NORTH ANNA POWER STATION, UNIT NO. 2

Amendment No. 41
License No. NPF-7

SAFETY EVALUATION BY THE OFFICE OF NUCLEAR REACTOR REGULATION

SUPPORTING AMENDMENT NO. 41 TO

FIGURE 2.1-1 REACTOR CORE SAFETY LIMITS FOR THREE LOOP OPERATION, 100% FLOW

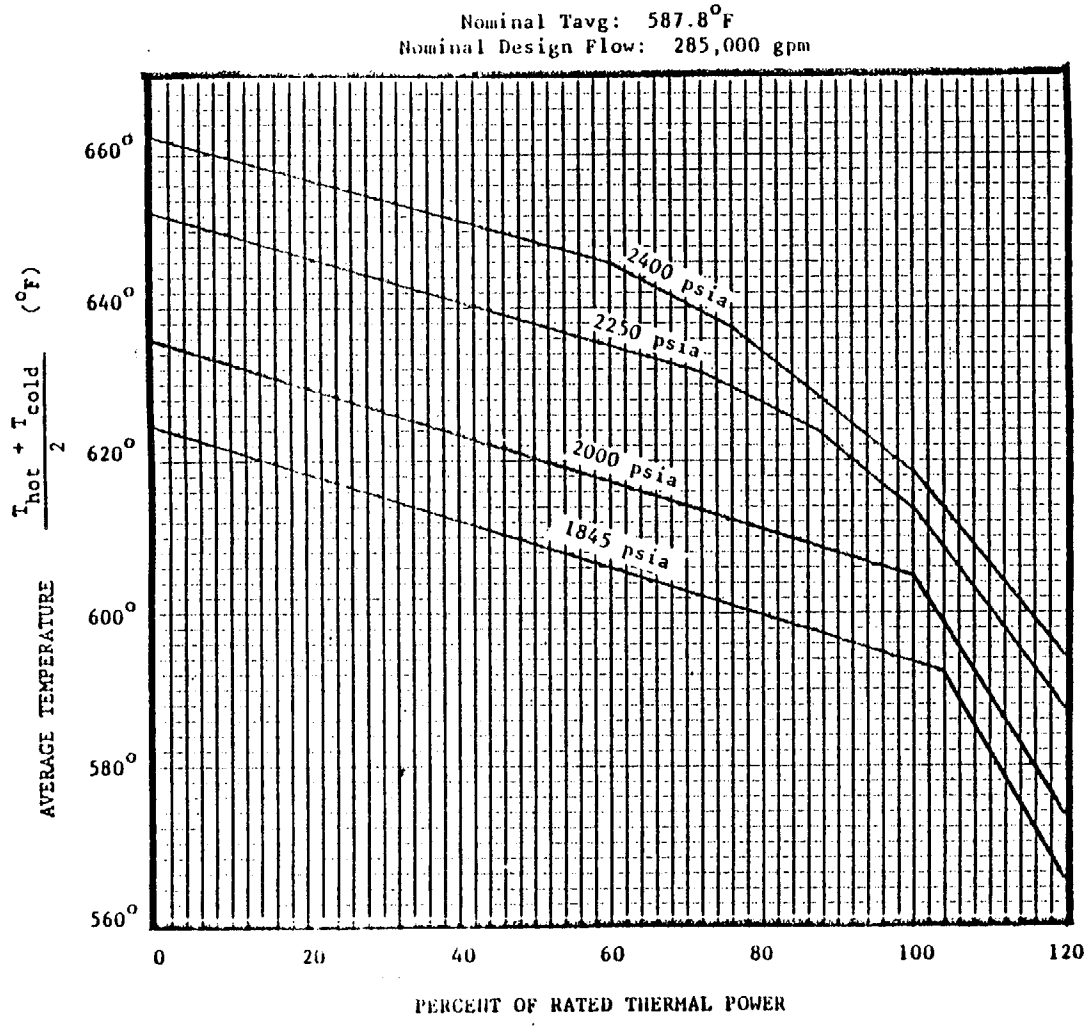
2.1.1 The combination of THERMAL POWER, pressurizer pressure, and the highest operating loop coolant temperature (T_{avg}) shall not exceed the limits shown in Figures 2.1-1 for 3 loop operation and 2.1-2 and 2.1-3 for 2 loop operation.
